MELFA Technical News

BFP-A6079-0223E

Subject: Notice of shape change of J1 axis mechanical stopper.

Affected item: RV-35/50/70F series

J1 axis mechanical stopper
Mounting position

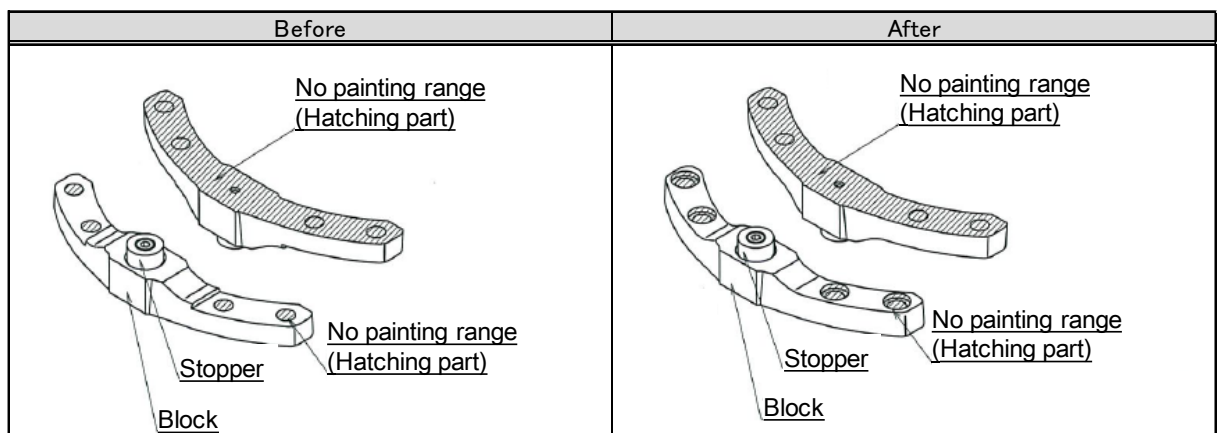
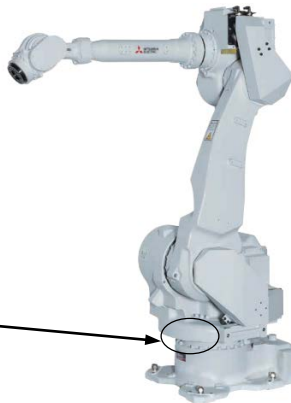
The shape around the mounting hole of the J1 axis mechanical stopper is changed from one side machining to counterbored hole machining.

Reason : To improve productivity.
